Access Compliance Report

Public Rights-of-Way

Intersection ID: 27468	Main Street: BALLANTYNE COMMONS PY	Cross Street: JOHN J DELANEY DR	Location: NE
ADA ID: E93ECE5779B3	Ramp Type: Perp	Initial Pass/Fail: Pass	Overall Compliance: No
Severity Score: 7.5			
Codes/Mitigation Info/Possible Solution		Field Measurements/Component Compliance

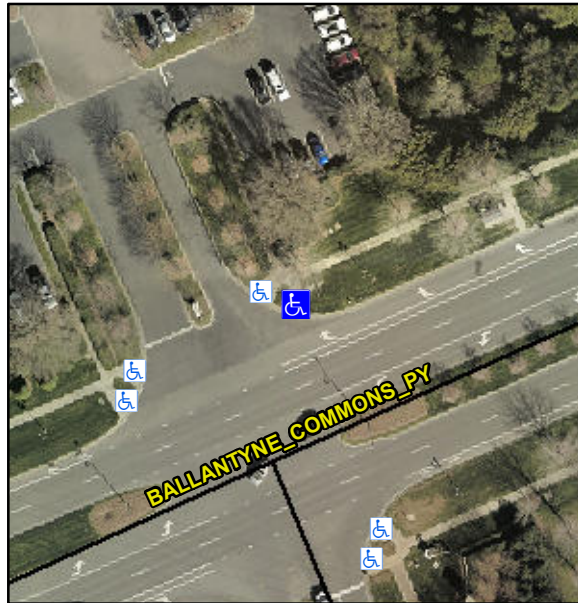
**Remove & Replace Entire Ramp.
Remove & Replace Gutter.**

**R304.2.2-Perp, R304.3.2-Para,
R305.1.4, R305.2, R304.5.4**
